American River Watershed Institute

Re: Supplemental Comments on Revised Proposed Regulations for the California Water Commission's Water Storage Investment Program Quantification Regulations

Example Scenario for French Meadows with +4 degree C and -25% precipitation

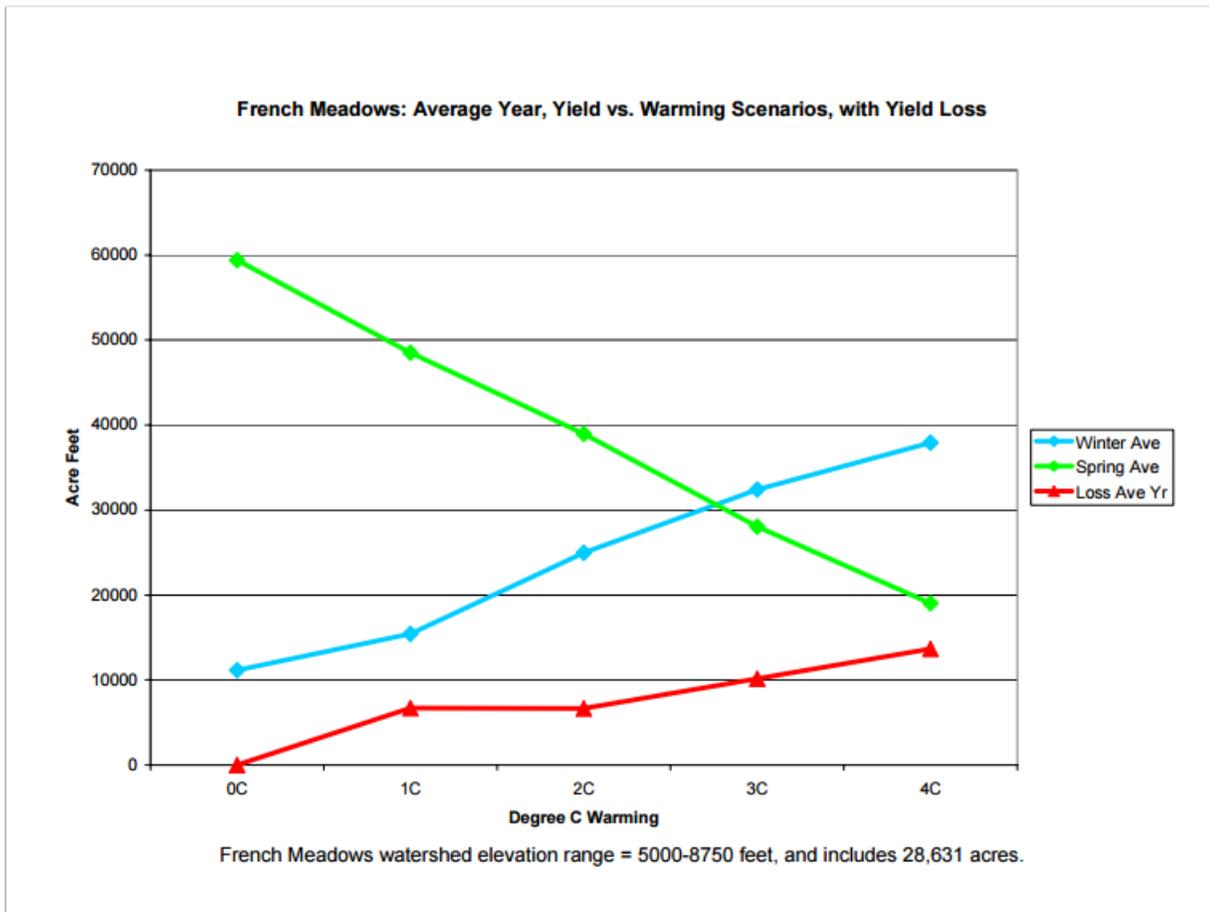
An example of the watershed calculator output is shown below. This example is the watershed yield calculation for French Meadows reservoir, which is 28,631 acres. The HRUs for the lower elevations have been entered, and only the final highest elevation band shows on the input screen. But the "total area entered" indicates that this is the accumulated total for the whole watershed. The parameters chosen were: 4 degrees C temperature rise, and 25% reduction in precipitation (which is not only within parameters of historic 1000 year tree ring history, but within parameters of some climate change scenarios).

The screen shows the baseline conditions for three water year types, the climate change scenarios for the three water year types based on the selected temperature and precipitation, and the percentage difference between the baseline condition and the chosen scenario. The data is presented in winter runoff, spring runoff, annual total runoff and April 1 snowpack.

ARWI recommends that the maximum level of scenario building be done for each project, within reason. It is reasonable that climate change scenarios for watershed yield be made by project proponents if their project falls within the study area.

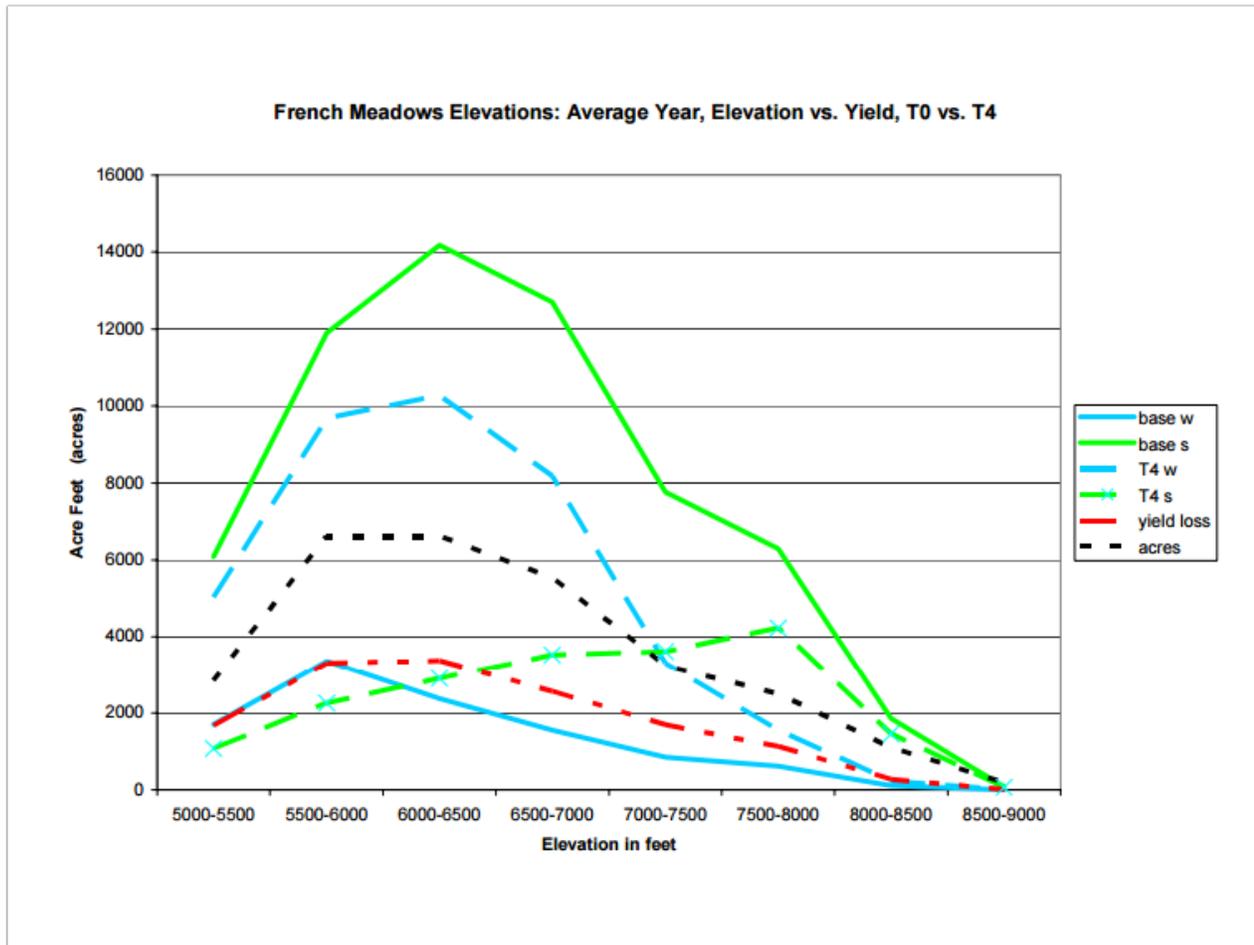
This type of data can be entered into graph form. The example below shows a French Meadows watershed example with the following parameters:
Precipitation baseline condition
Output from four temperature scenarios

The following graph shows the baseline precipitation condition, with the baseline temperature condition (solid lines) plotted against the +4 degree C scenario (dotted lines).

These examples demonstrate how this tool can provide important risk assessment information to both project proponent and the Commission. The tool can be easily used by anyone with a basic skill in ArcMap, to generate the HRU profiles for the catchment in question. The exercise is not difficult, not time consuming, and generally can be accomplished by water agency staff.
